ISLAND PLAN 2022-25: APPROVAL (P.36/2021) – EIGHTY-NINTH AMENDMENT (P.36/2021 AMD.(89)) – AMENDMENT

Lodged au Greffe on 14th February 2022 by the Deputy of St. Peter

PAGE 2, PARAGRAPH (c) –

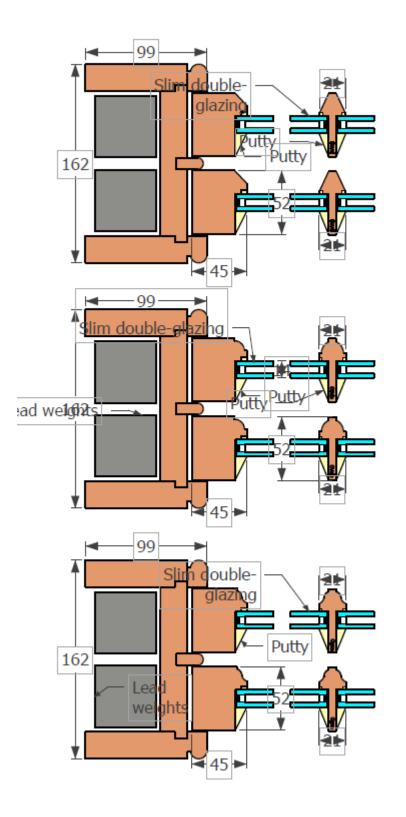
Whilst the use of double-glazing and 'modern' frame sin historic buildings may be controversial, as the pictures below will evidence, there is no discernible visual impact when they are correctly fitted. To illustrate the point can Members determine which window below is double-glazed and has a 'modern frame', and which has not? It is anticipated that Members will be unable to distinguish between the two!
